# PARAJET TECHNICAL ADVISORY BULLETIN

## OCTOBER 2022 - UPRATED FUEL CAP REPLACEMENT

PJ-P-10088 : Fuel Tank Cap

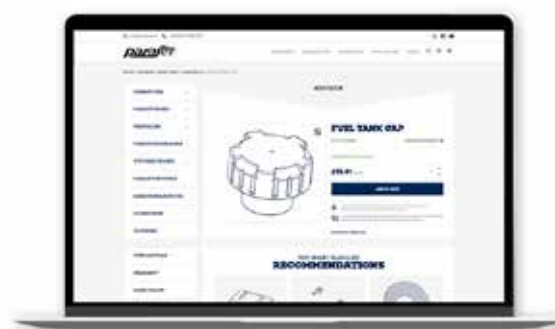
Parajet are aware of an extremely small number of cases where the fuel cap has not allowed sufficient air to enter the tank during use, creating a vacuum inside the tank and starving the engine of fuel.

Repeated exposure to excessive pressurisation without correct ventilation can lead to tank degradation, including deformation, splits, and tank ruptures.

An investigation was opened and following an immediate full batch inspection and review, our design engineers identified the OEM valve component at fault and have issued an in-house upgrade to better allow airflow to be drawn into the fuel tank at the optimum rate, avoiding vacuum build-up and fuel starvation to the engine.

This updated fuel cap is a direct replacement and should be immediately fitted to the tank and the old cap discarded.
